FORM APPROVED
OMB NO. 1004-0135
Expires: July 31, 2010**SUNDRY NOTICES AND REPORTS ON WELLS**
*Do not use this form for proposals to drill or to re-enter an abandoned well. Use form 3160-3 (APD) for such proposals.***SUBMIT IN TRIPLICATE - Other instructions on reverse side.**

Haracz AMO Federal #10H

Yates Petroleum Corporation respectfully requests to make the following changes to the approved APD:

WELL DETAILS: #10H

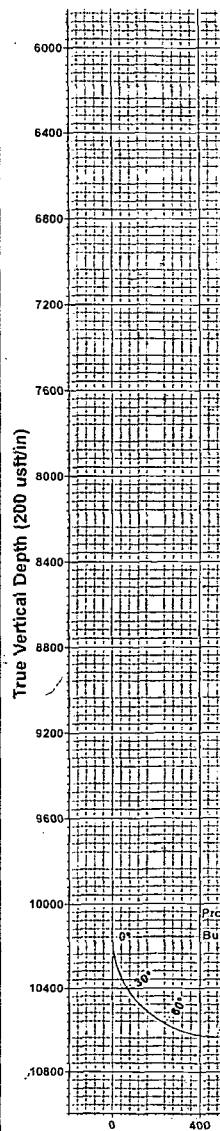
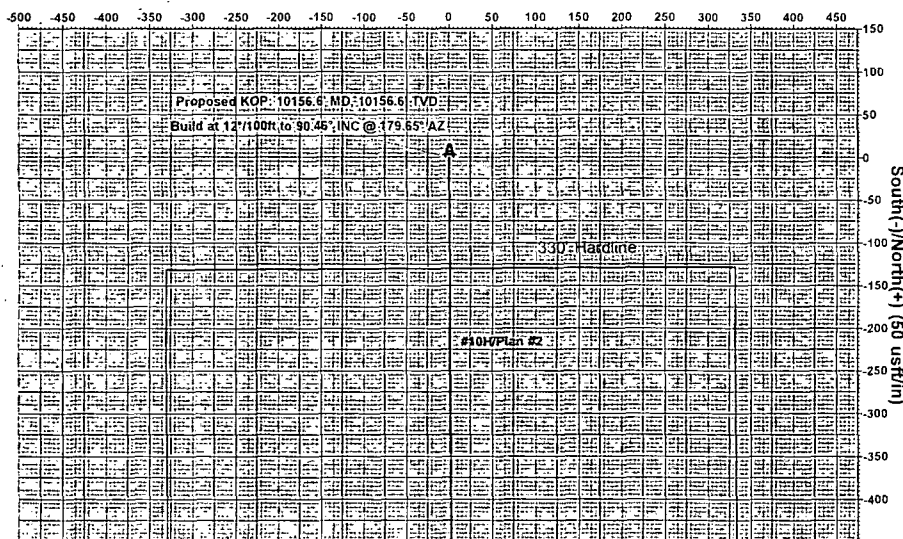
Well will be drilled to approx. 15279' MD (10599' TVD) which will be 100' past the 330' hardline. The BHL, casing weight and grade will remain the same. Production cement volumes will be adjusted accordingly to include the extra 100' of lateral. The directional plan and WM are attached.
